Memorandum

TO: Columbia River Crossing Task Force
FROM: CRC Pedestrian and Bicycle Advisory Committee (PBAC)
SUBJECT: PBAC Recommendations for World Class Pedestrian and Bicycle Facilities

The I-5 Bridge Must Include a “World-Class” Pedestrian and Bicycle Facility

PBAC Proposed Pedestrian and Bicycle System for Replacement Bridge

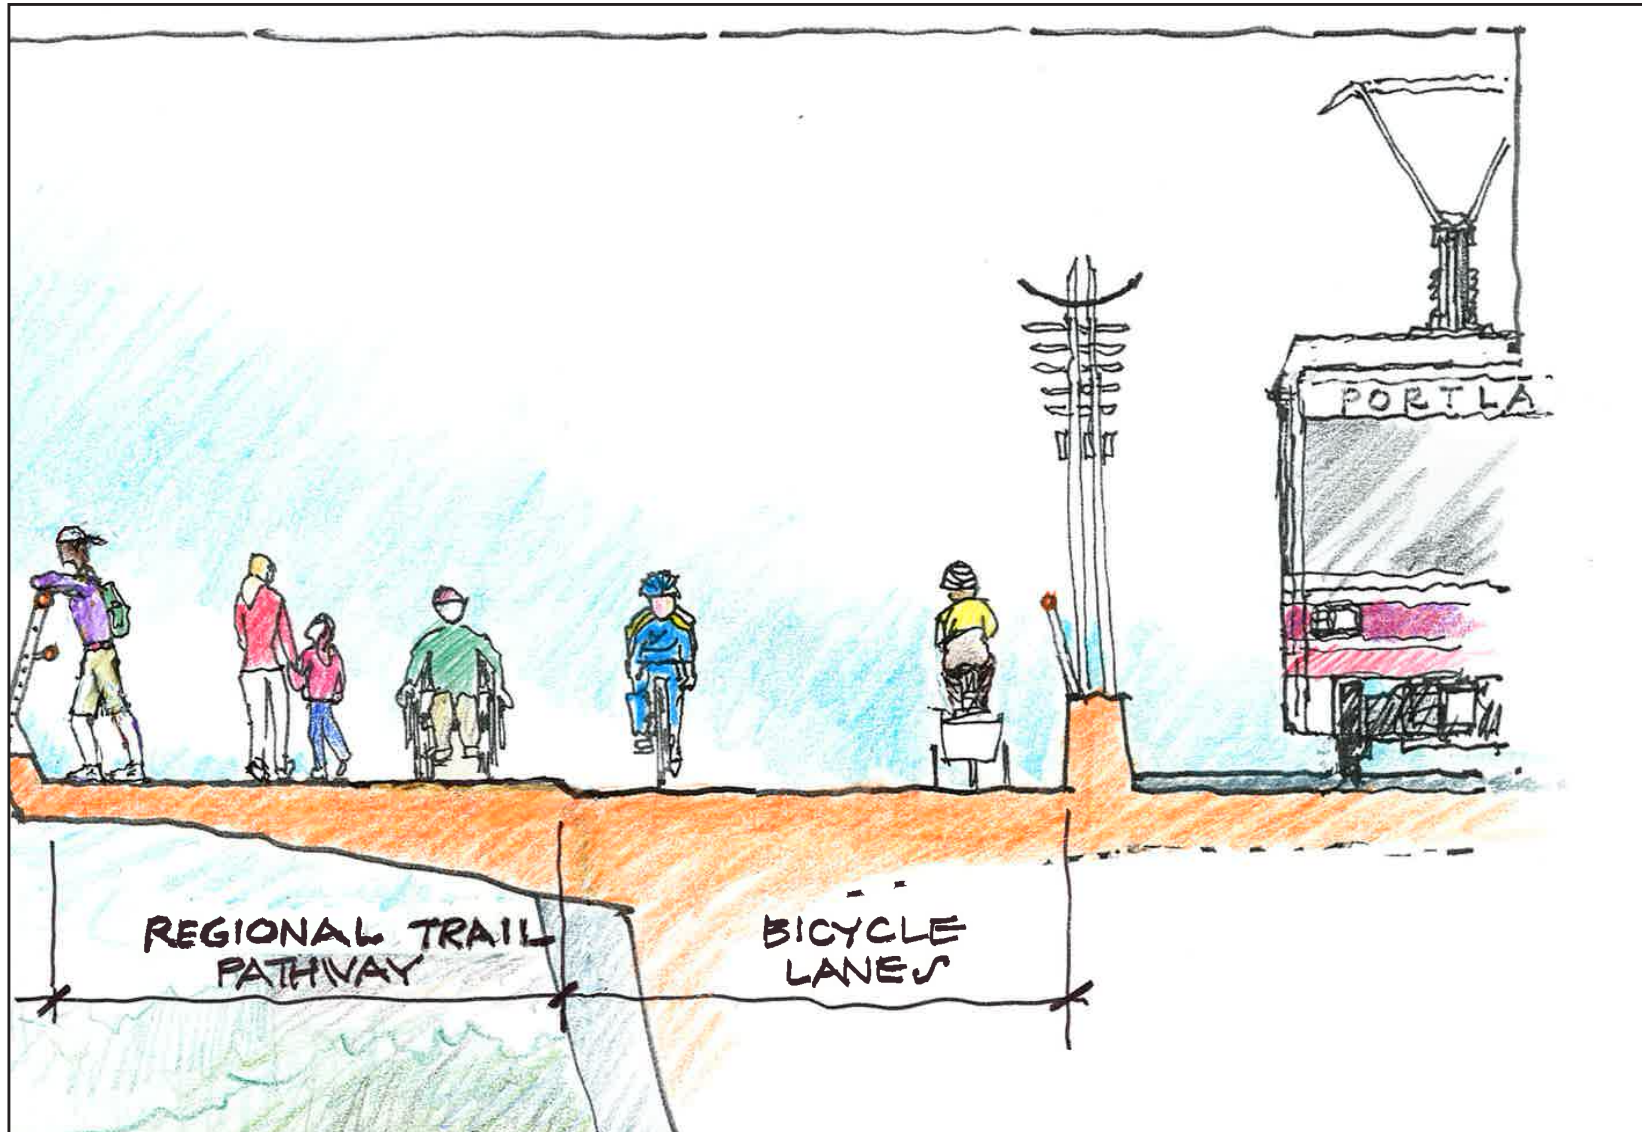
- The overall pathway on the western bridge (adjacent to the transit guideway) must provide separation between recreational users and higher speed bicycle users. To provide this separation, a 12-foot wide regional trail should be provided adjacent to, and to the west of, a pair of six-foot wide bicycle lanes (see attached rendering). These recommended widths are exclusive of potentially needed shy distances, i.e., free and clear of poles and other obstructions to enable safe pedestrian and bicycle movement (a summary of agency standards for multiuse paths, sidewalks and bike lanes is attached).

The regional trail would accommodate pedestrians, persons with disabilities, seniors, families with children, tourists, roller-skaters, and recreational bicycle riders. The adjacent bicycle lanes would be used by bicycle commuters and other faster-moving bicyclists. The regional trail would be at a slightly higher level than the bicycle lanes, but bicyclists in the bicycle lanes would be able to access the trail. Different paving treatments and/or patterns should differentiate the regional trail and the bicycle lanes.
